STAFF RECOMMENDATION
3923 Kimpalong Avenue
July 21, 2021

Application: New Construction—Addition and Outbuilding (DADU); Partial Demolition

District: Woodlawn West Neighborhood Conservation Zoning Overlay

Description of Project: Application is to construct a rear addition that extends wider than the historic house and to construct an outbuilding that includes a dwelling unit.

Figure 4. Proposed left-side façade; existing addition to be altered outlined in green.

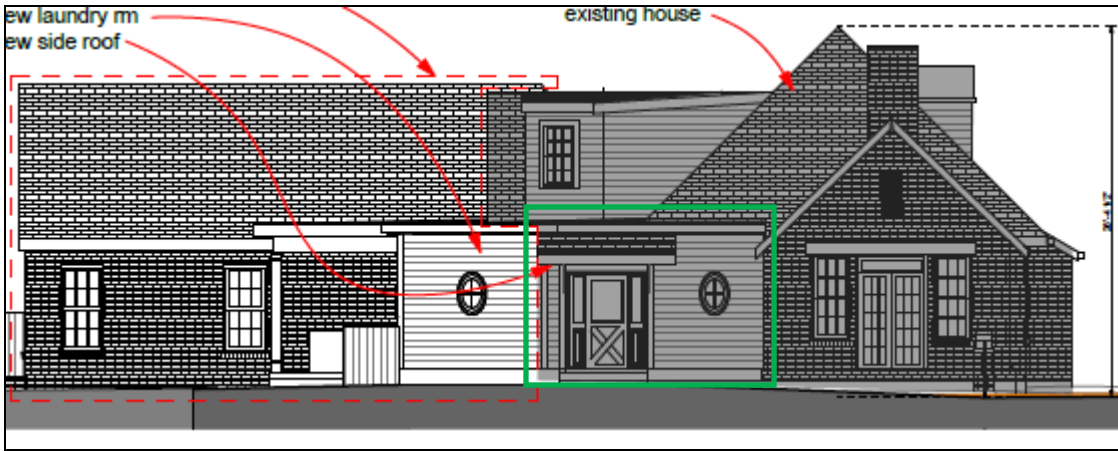
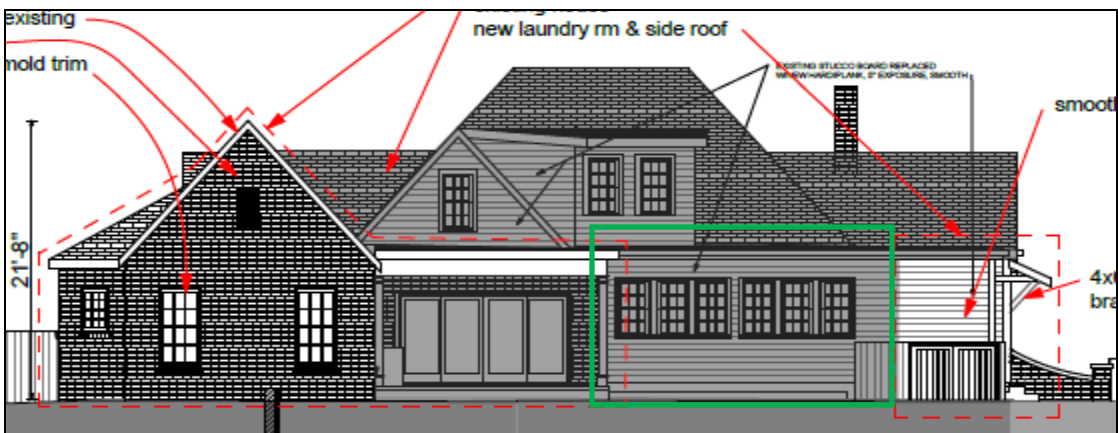
Partial Demolition: The plan includes re-working existing board-and-batten clad rear additions that were permitted in 2007 (building permit # 200711734) (Figures 2-3). The work includes replacing the cladding with smooth Hardie plank siding and adding windows to the both the rear and side façades as well as a recessed porch with bracketed shed awning on the left-side façade (Figures 4-5).

Given that the proposed partial demolition is to a later addition, staff finds that the proposed partial demolition meets Section III.B.1 of the design guidelines.

Figure 7. Proposed addition wrapping rear corner.

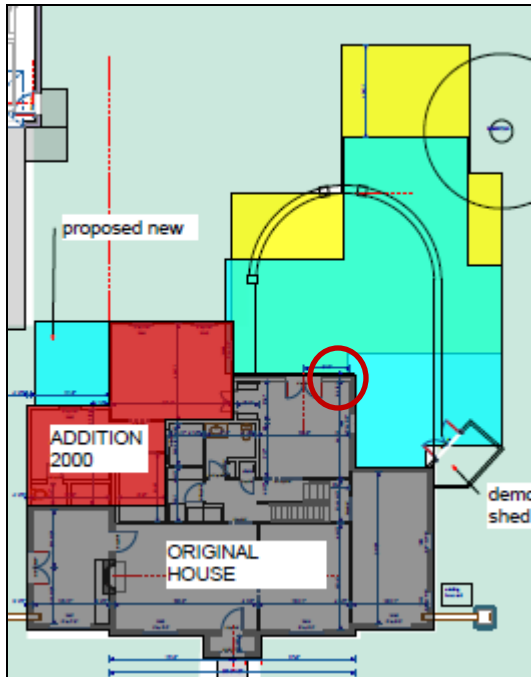
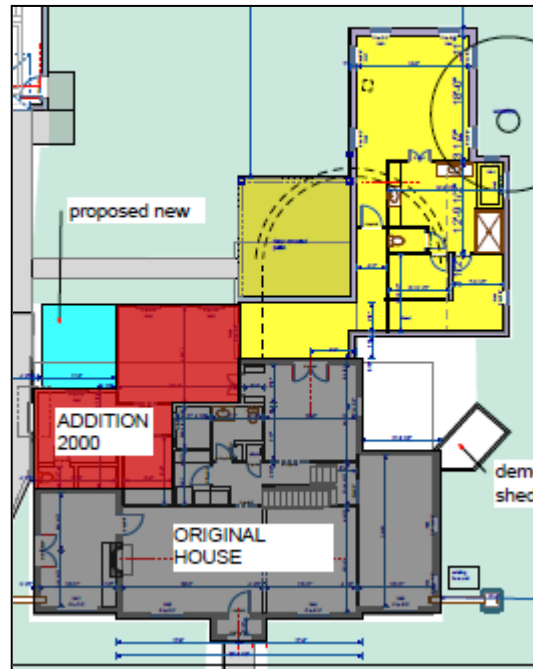
The portion of the addition that extends wider is one-story with a ridge and eave heights that do not exceed that of the historic building. The design guidelines also require that “the addition is designed to

leave the corners of the building visible and intact” and to “not wrap around a corner.” The proposed addition sets in one foot (1’) from the rear corner of the side-gabled portion of the house and wraps around the rear corner of the rear-facing gabled piece that appears on the 1931 Sanborn map (Figures 6-7). The addition would go back three feet (3’) before coming out nine feet, ten inches (9’-10”) wider than the existing house. The applicant included a plan that illustrates where staff recommends that the addition should attach based on the 1931 footprint in order to meet the design guidelines (Figure 8).

Figure 8. Addition inset from rear corner per staff’s recommendation.

With the condition that the addition not wrap the right rear corner, staff finds that the project can meet Sections VI.A and VI.B.

Figure 9. Left-side façade.

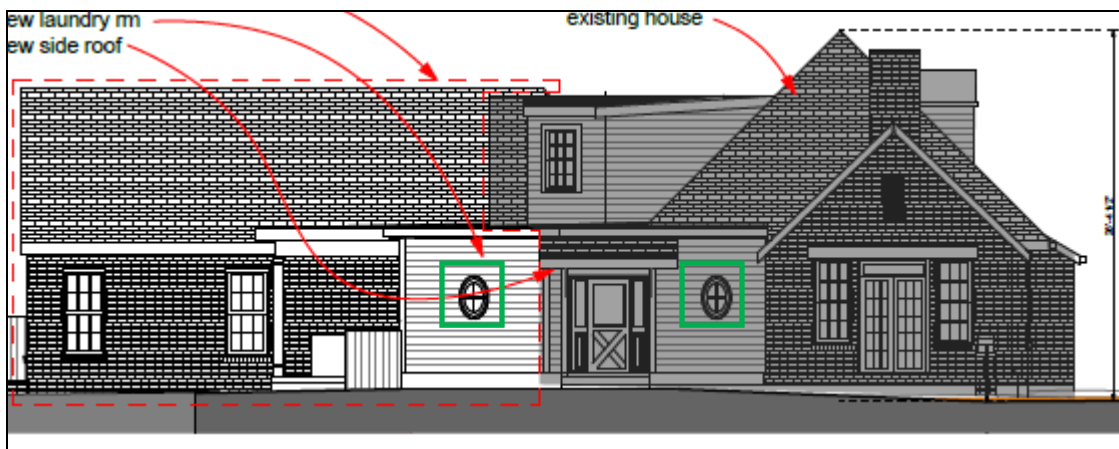
Proportion and Rhythm of Openings: Most of the windows on the proposed addition are all generally twice as tall as they are wide, thereby meeting the historic proportions of openings. The plan includes two oval windows on the left-side façade that are not representative of the window patterns of the historic building (Figure 9). Staff finds that the proposed oval windows openings are not appropriate on the side façades and could be replaced with square openings or smaller rectangular openings that are twice as tall as they are wide. Also, it would be appropriate to relocate the oval openings to the rear façade if desired. There are no large expanses of wall space without a window or door opening.

1. The addition shall not wrap the rear corner on the right-side of the historic house;
2. The oval window openings on the left-side façade be either square openings or rectangular openings that are twice as tall as they are wide;

Staff finds the project’s proportion and rhythm of openings to meet Section VI.D.
